**Fenwick Solar Farm
EN010152**

**Landscape and Visual Supplementary Report
Document Reference: EN010152/APP/8.23**

- 1.1.1 Iceni Projects (Iceni) have prepared this Landscape and Visual Supplementary Report in response to the Relevant Representation made by City of Doncaster Council (CDC) **[RR-001]** (CDC's Relevant Representation) in relation to the proposed Fenwick Solar Farm (the Proposed Development). This was informed by a review of the Landscape and Visual Impact Assessment (LVIA) which was carried out by LUC on behalf of CDC.

FIGURE NUMBER
Figure 8-5-2

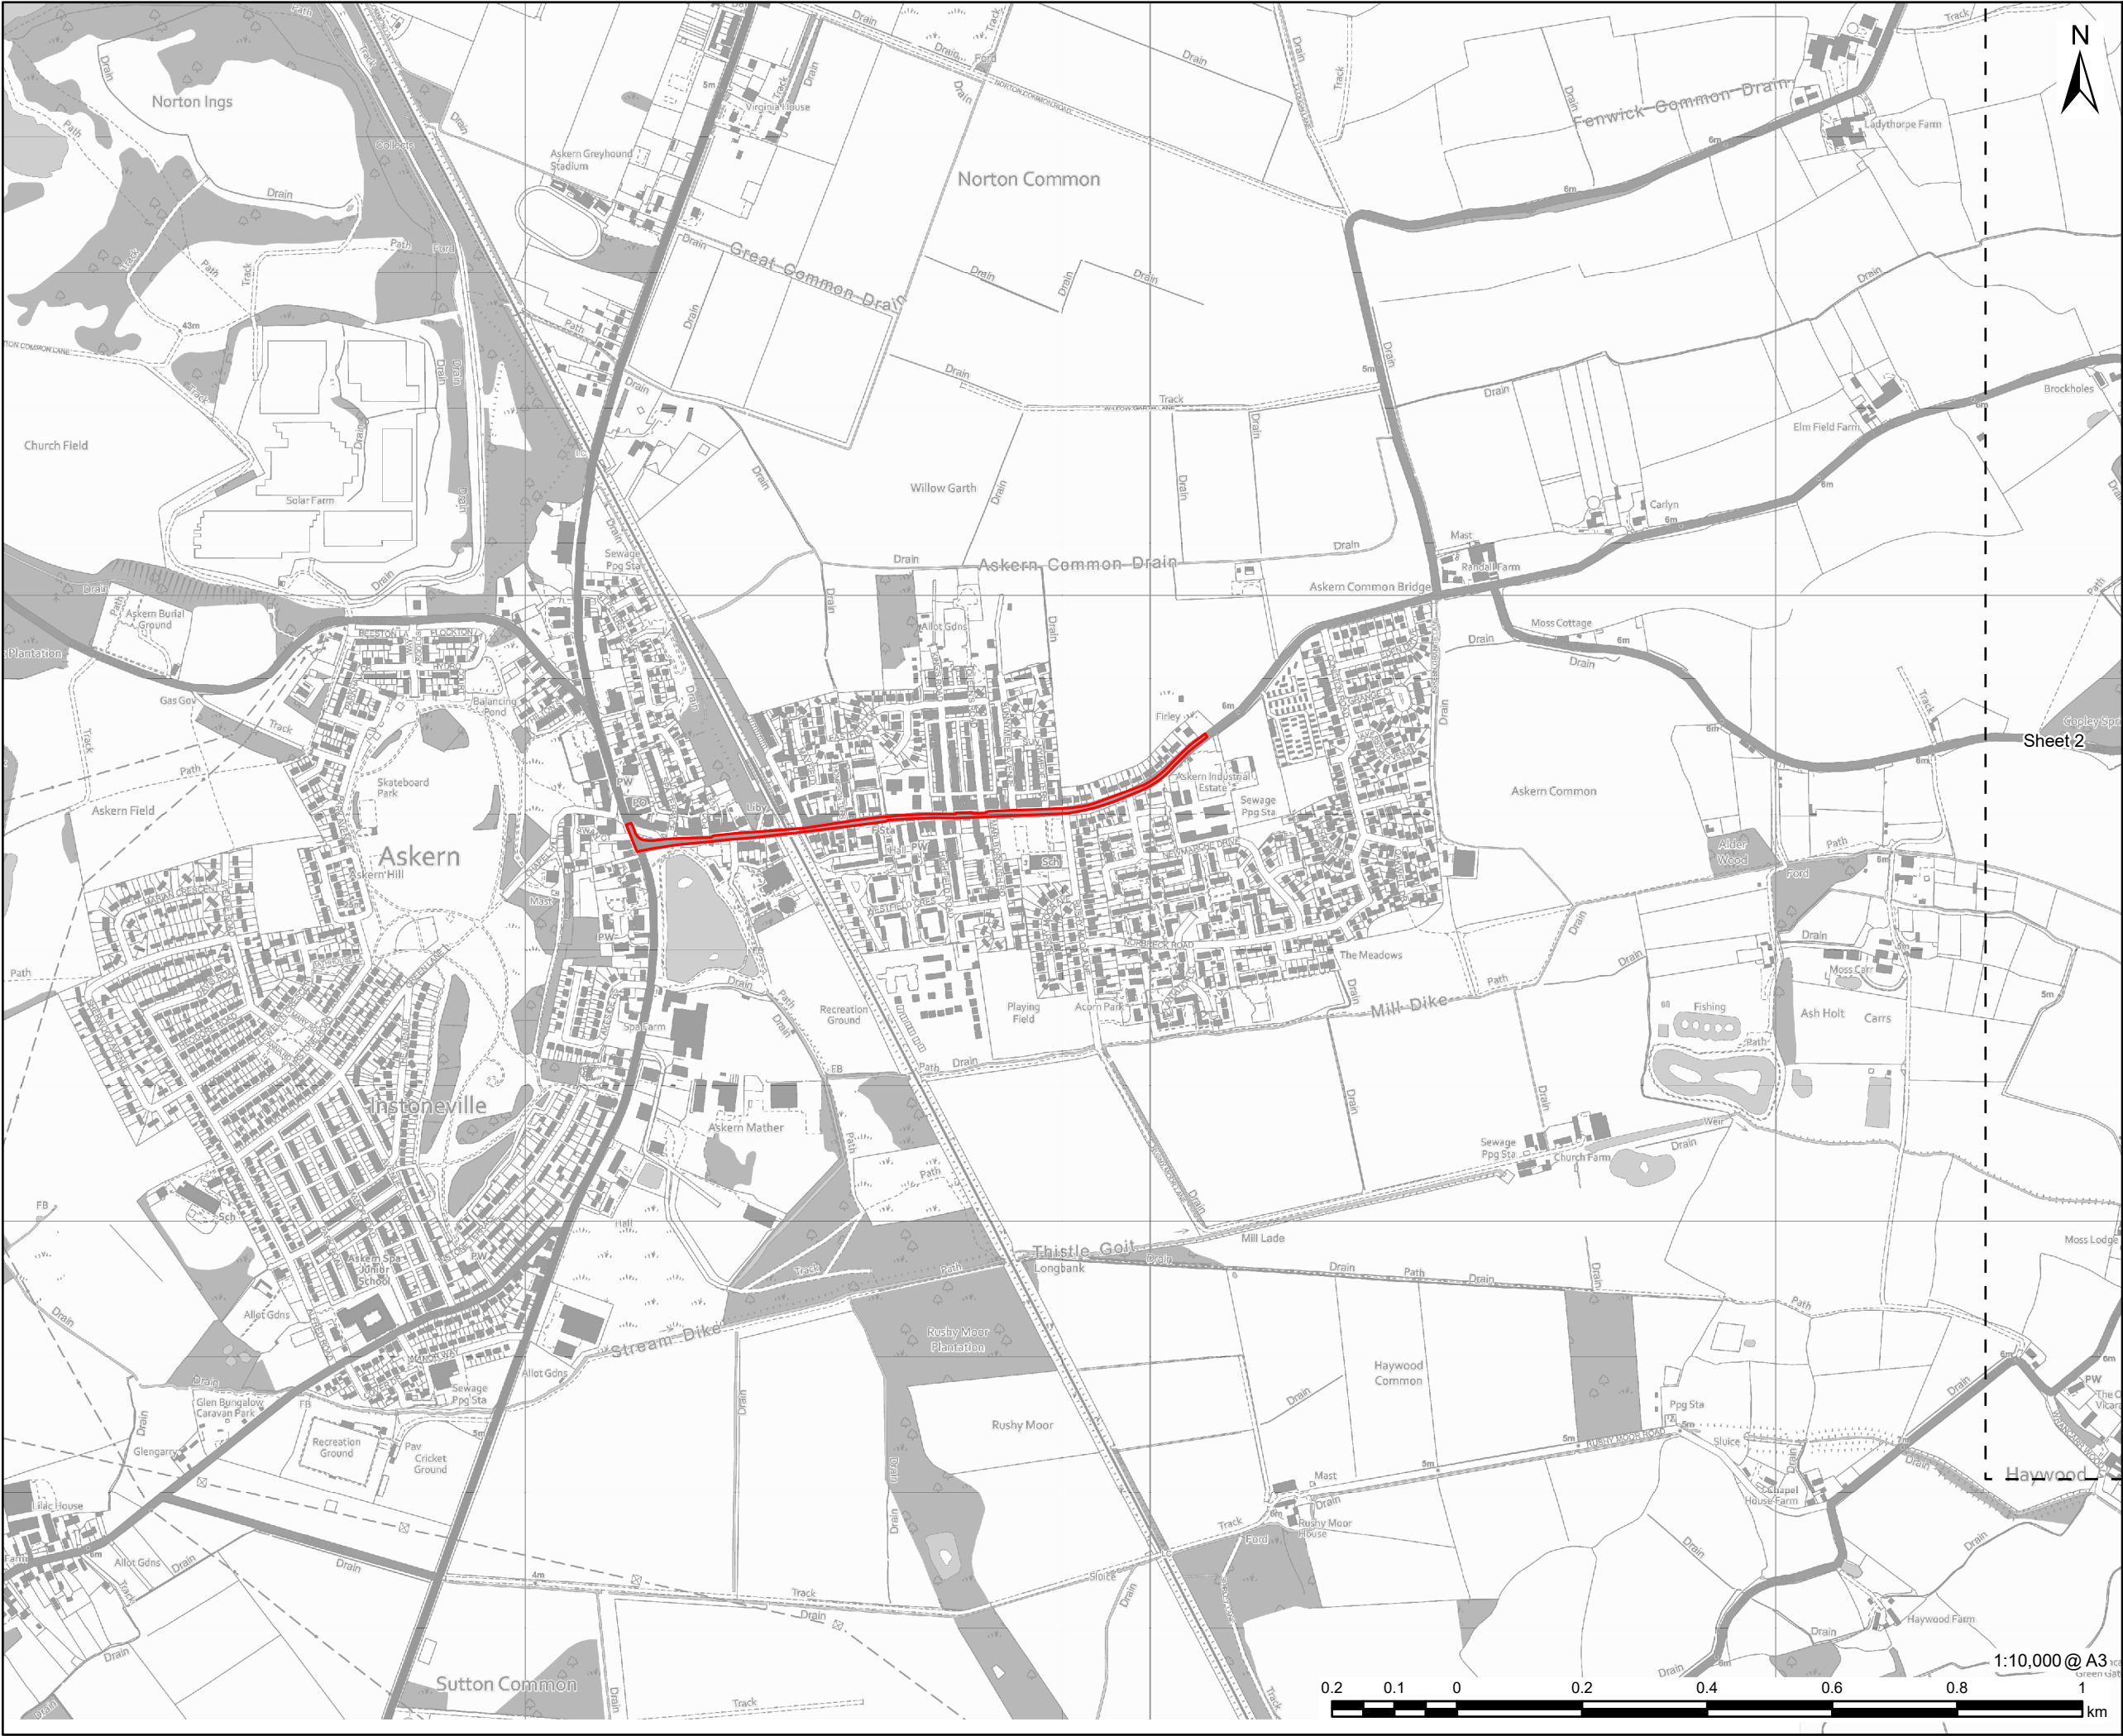
2.1.35 Whilst the Scheme does propose the removal of some stretches of hedgerow and trees to accommodate access and the laying of cables, as shown on Figure 8-5-2: Hedgerow Removal in **ES Volume III Appendix 8-5: Hedgerow Report [APP-150]**, there would be an overall increase in structural vegetation, habitat and natural capital assets across the Site. As noted within the **Biodiversity Net Gain Assessment [APP-200]**, there would be a 36.46% increase in habitat area units, a 62.75% increase in hedgerow units, and a 24.97% increase in watercourse units, resulting from habitat enhancement and creation across the Solar PV Site and Grid Connection Corridor. These would be established at Year 15 and would therefore bring with them beneficial landscape change.

- The Scheme avoids the need to fell woodland, including at Bunfold Shaw. Vegetation removal has been limited to where necessary for access and laying the of cables, as shown on Figure 8-5-2: Hedgerow Removal in **ES Volume III Appendix 8-5: Hedgerow Report [APP-150]**.
